Vertical stabilizer modification

FIGURE 1-1
Vertical Stabilizer Modification

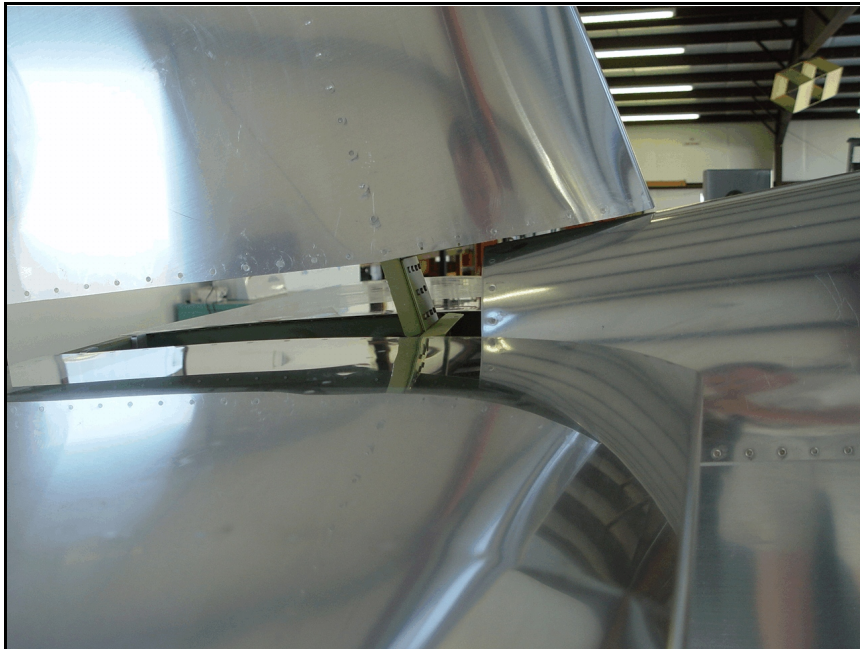
Relocate the VS-705 nose rib and trim the VS-801pp skin referring to figure 1-1. Drill new holes in the VS-801pp skin and VS-705 nose rib using the same spacing, (*NOTE; if the nose rib has already been installed, back drill the new holes using the rib as a guide*) drill a new hole at the first location fwd of the spar left and right maintaining edge distance.
